Model type:
LV460WH

Commercial code:
F030373

Notices

n1045085: Introduction of new litre counter turbine integrated on air-break.

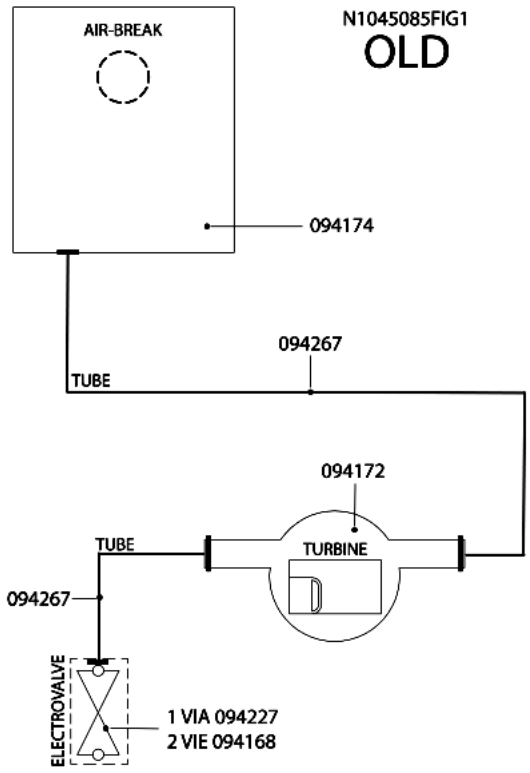
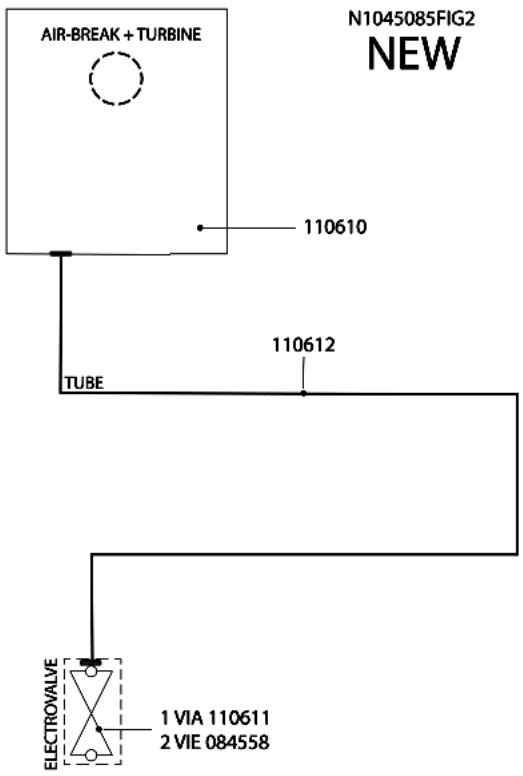
All dishwashers affected by this note have been equipped with a new litre counter turbine on the air-break.
Picture N1045085FIG1 illustrates the premodification structure, picture N1045085FIG2 the new structure.

AIR-BREAK:
new 110610;
premodification 094174;
the new item features a new integrated litre counter turbine and its water supply hose has a smaller diameter.

LITRE COUNTER TURBINE code 094172 has been eliminated.

SOLENOID VALVES:
new:
1-WAY code 110611;
2-WAY code 084558(Rohs 143737);
premodification:
1-WAY code 094227;
2-WAY code 094168;
the new solenoid valves have a smaller diameter drain hose fitting.

HOSES:
new solenoid valve hose/air-break code 110612;
premodification turbine hose/air-break code 094267;
premodification solenoid valve hose/air-break code 094267;
the new hose has a smaller internal diameter.

WIRING:
the litre counter turbine connecting cable is longer, but since the connector is the same, the new item can be used in place of the premodification one.

n1045087: Introduction of recessed heating element.

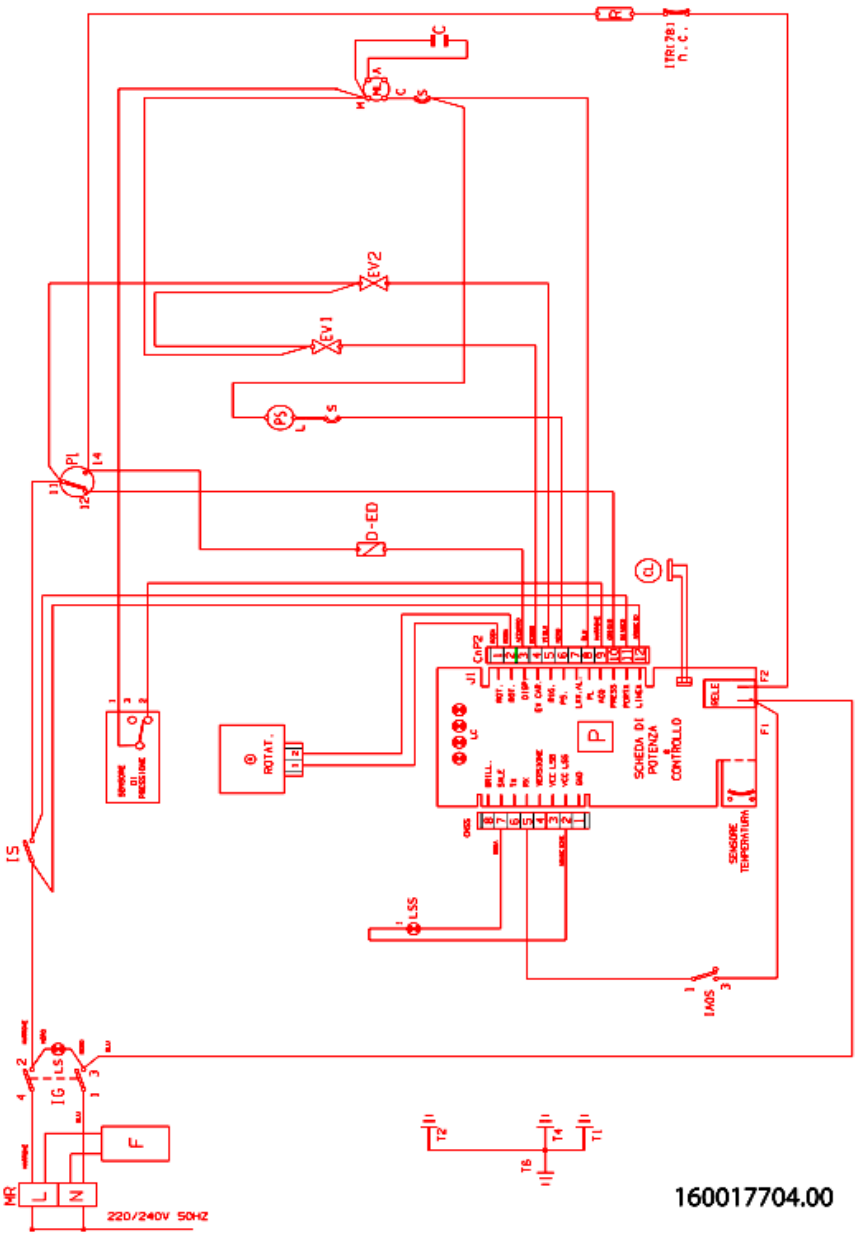
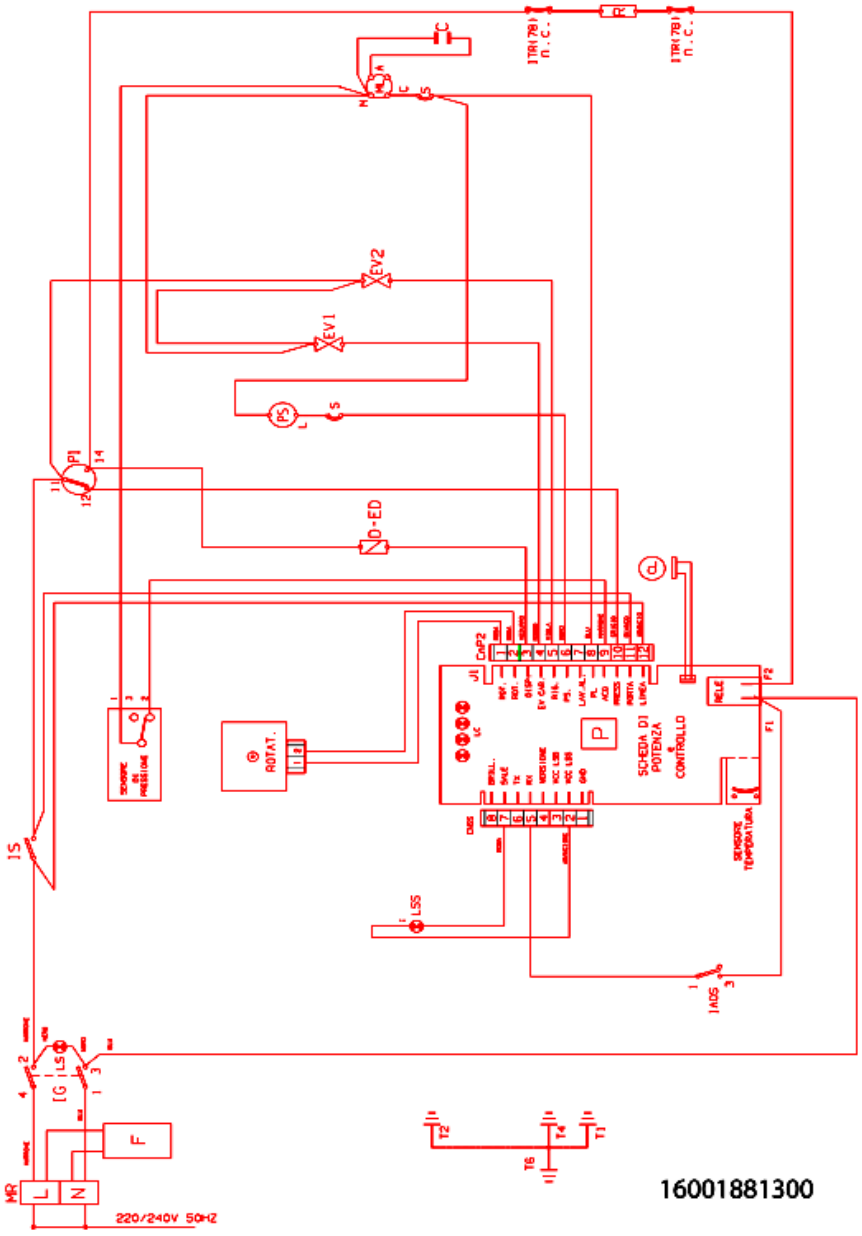
From serial no. 40624.0001, all dishwashers affected by this note have been equipped with a recessed heating element in place of the exposed one located inside the tank.
Given below are the codes of the items concerned:

ELIMINATED ITEMS:
nut + washer code 097871
o-ring seal code 063792
temperature probe code 063791
safety thermostat code 041086
exposed heating element code 066602
heater terminal protection code 074714
upper impeller supply tube code 056001
electrical pump connection tube - upper impeller supply tube code 076233
heater bracket code 054872

INTRODUCED ITEMS:
recessed heating element code 074000
upper impeller supply tube code 094152
heater coupling support code 078394
electrical pump connection tube - heating element code 057710

LV460WH (comm. code 30373)
Wiring Diagram: premodification 16001770400 new 16001881300
Wiring: premodification 110376 new 112487
